# TOWN OF GLASTONBURY

GL-2013-05

## HOPEWELL ELEMENTARY SCHOOL – BOILER REPLACEMENT ADDENDUM #2 APRIL 13, 2012

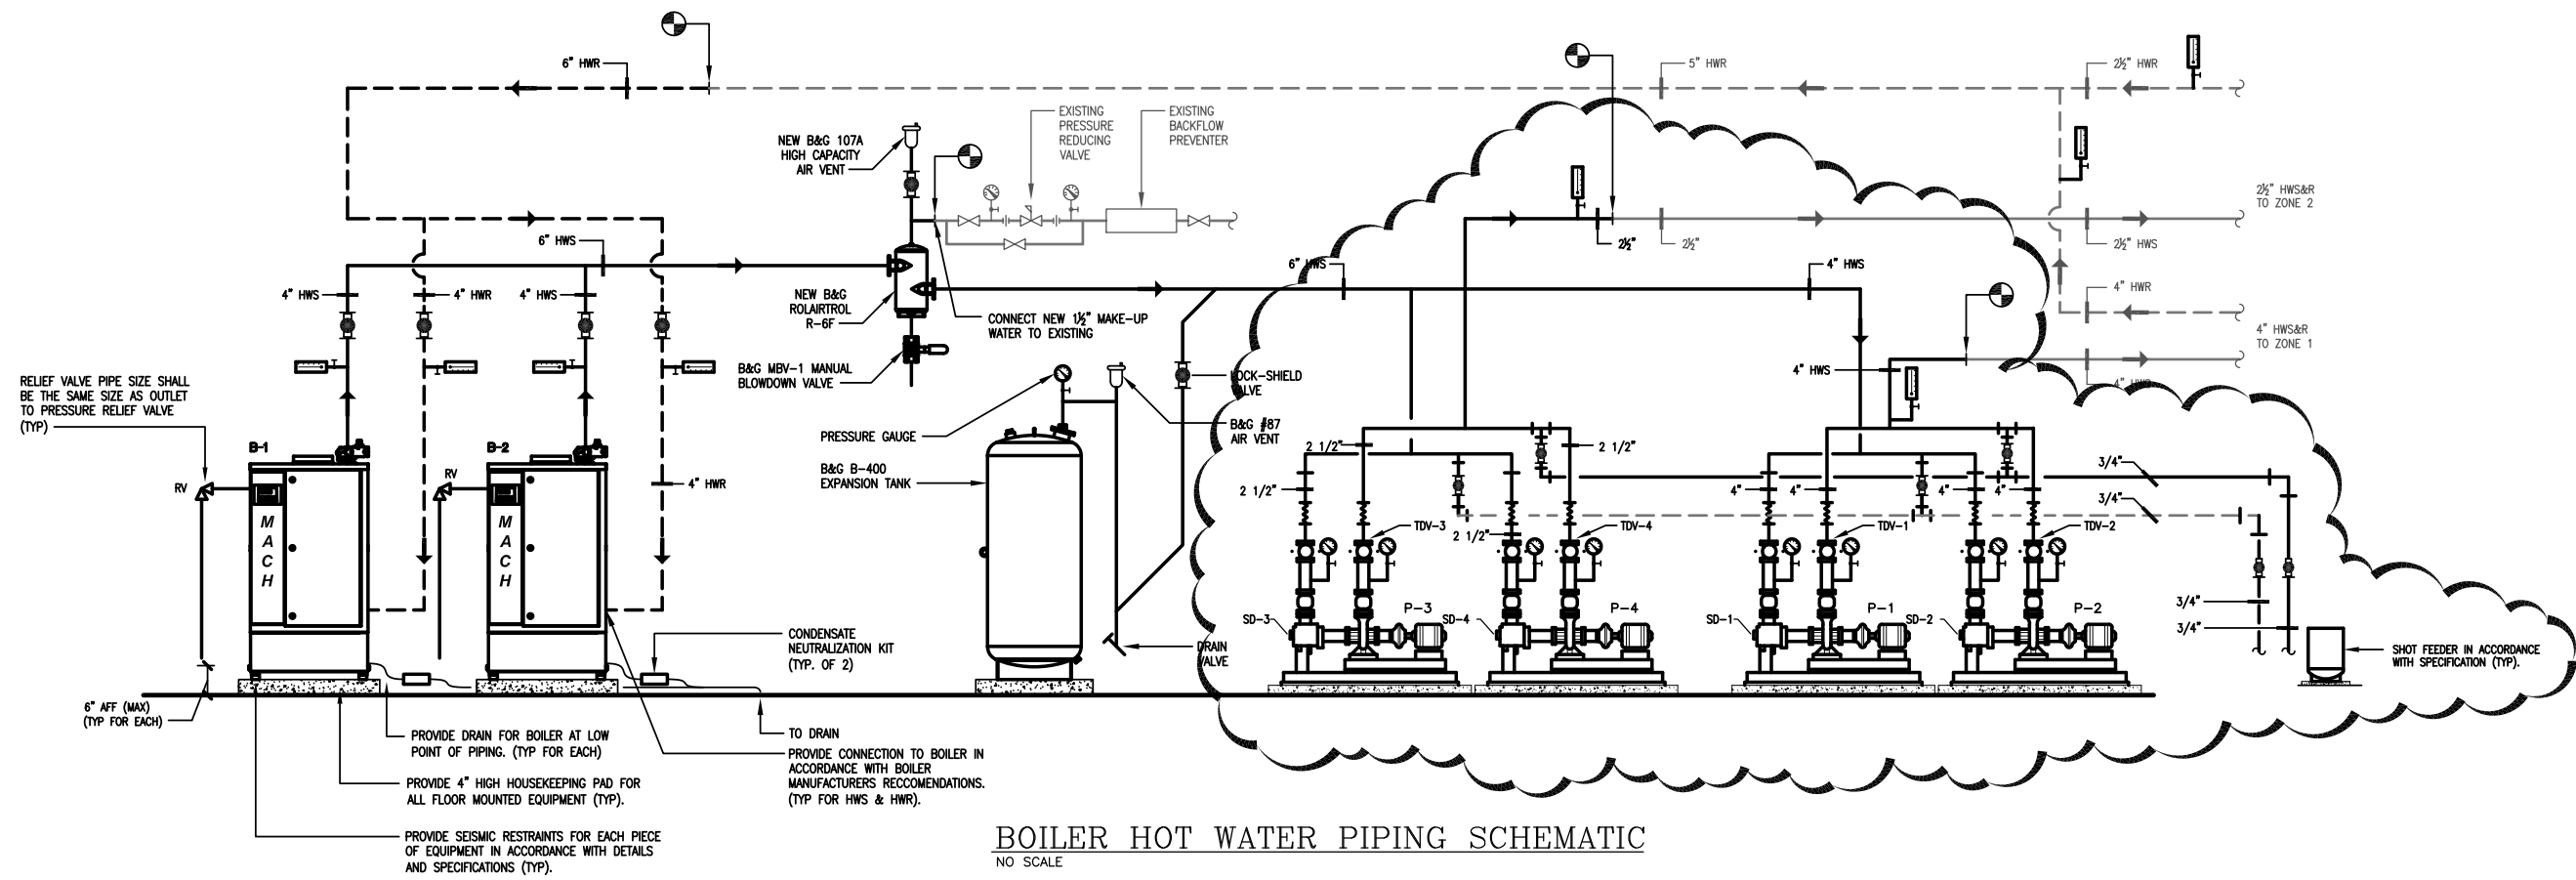
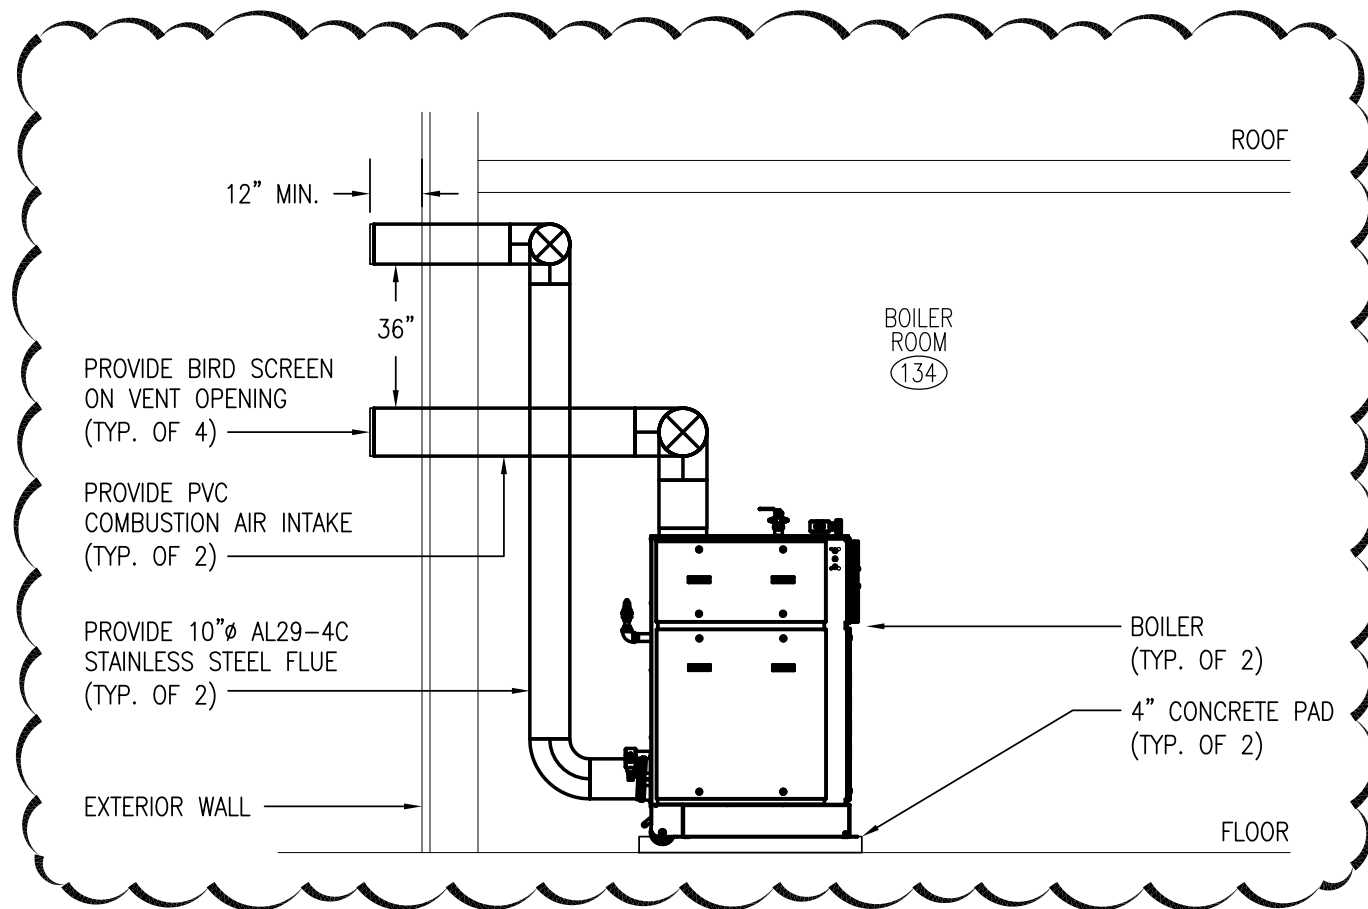
Question #5: Drawing M2.0 Boiler water piping schematic show's P-1 , P-2 tied together without suction diffusers. Pump schedule calls for suction diffusers. Are they required?

Answer: Suction diffusers are required. Please refer to revised piping diagram SKM-6.

MSK-7

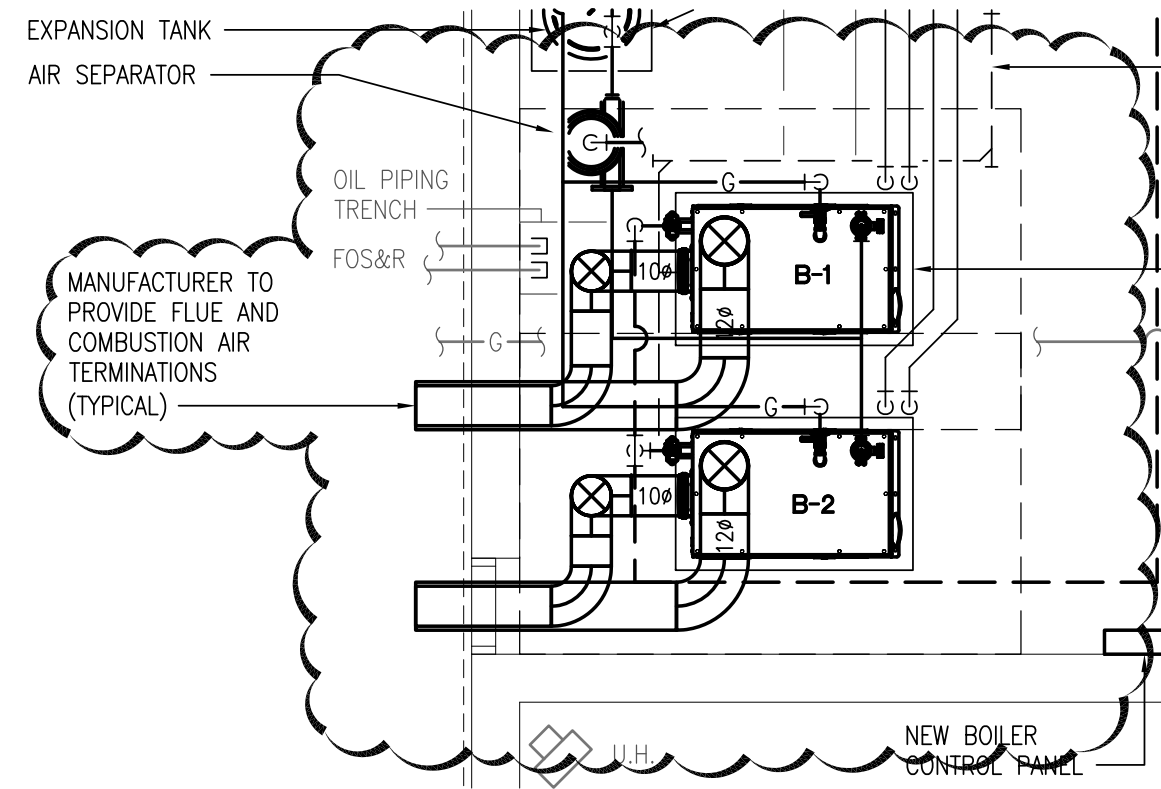
Question #4: Drawing M2.0 Should both the air inlet and the exhaust vent terminate on the same wall? MACH Model C2500 installation manual page 22 paragraph 3.5.5 indicates it should

Answer: Both combustion air intake and exhaust shall be located on the side wall. Please refer to SKM-7.
